Access Compliance Report

Public Rights-of-Way

(Curb Ramps)

Intersection ID: 11738	Main Street: SCARLET_SAGE_DR	Cross Street: SWEET_PLUM_DR	Location: NE
ADA ID: 86F374A459C1	Ramp Type: BlendTrans1	Initial Pass/Fail: Fail	Overall Compliance: No
Severity Score: 42.5			
Codes/Mitigation Info/Possible Solution		Field Measurements/Component Compliance

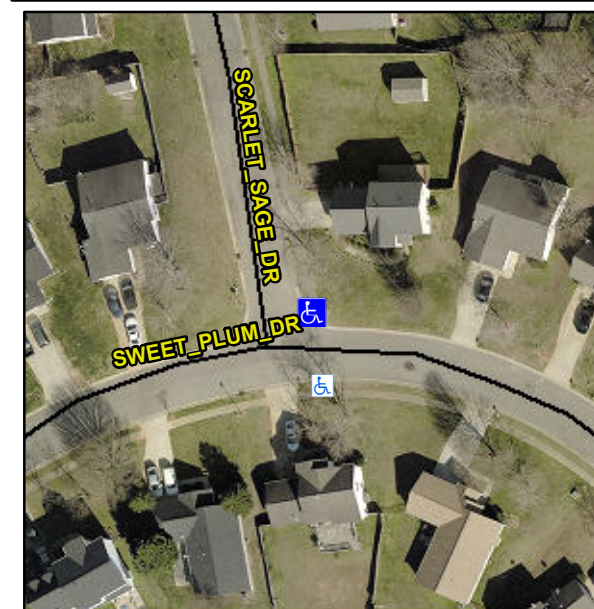
NO RT SW

Not Found, R304.5.1, R304.5.3

Compliance	Description	Data	Compliance	Description	Data
N/A	Ramp Length (in)	96.0	Yes	BlendTrans Slope (%)	2.3
No	Ramp Width (in)	33.0	No	BlendTrans XSlope (%)	8.1
N/A	Flare Type LT	N/A	N/A	Flare Type RT	N/A
N/A	Flare Slope LT (%)	N/A	N/A	Flare Slope RT (%)	N/A
N/A	Flare Traversable LT?	N/A	N/A	Flare Traversable RT?	N/A
N/A	Landing Length (in)	N/A	N/A	DWS Provided?	N/A
N/A	Landing Width (in)	N/A	N/A	DWS Contrast?	N/A
N/A	Landing Slope (%)	N/A	N/A	DWS Length (in)	N/A
N/A	Landing X Slope (%)	N/A	N/A	DWS Full Width?	N/A
N/A	Landing Curb? (Y/N)	N/A	N/A	DWS Offset (in)	N/A
N/A	Shared Landing?	N/A			
N/A	Gutter Ponding?	N/A	N/A	Gutter Slope (%)	N/A
N/A	Gutter Lip Ht (in)	N/A	N/A	Gutter X Slope (%)	N/A
N/A	Painted X Walk1?	No	N/A	Painted X Walk2?	N/A
	X Walk 1 Direction	To S		X Walk 2 Direction	N/A
	X Walk 1 Width (in)	N/A		X Walk 2 Width (in)	N/A
	X Walk 1 Slope (%)	3.5		X Walk 2 Slope (%)	N/A
	X Walk 1 X Slope (%)	8.1		X Walk 2 X Slope (%)	N/A

N/A	Ramp inside XWalk1?	N/A	N/A	Ramp inside XWalk2?	N/A
	Road Slope (%)	8.1		Clear Space?	N/A
	Road X Slope (%)	3.5	N/A	Clear Space to XWalk (in)	N/A
N/A	Any Obstructions?	N/A	N/A	Storm Grate/Utility Hazard?	N/A
	Obstruction Type			Storm Grate/Utility Type	
		N/A			N/A
			Yes	Surface Condition? (G/P)	Good
			No	Curb Slope (%)	17.1

Remove & Replace Curb Ramp With Two New Directional Ramps or Equivalent.
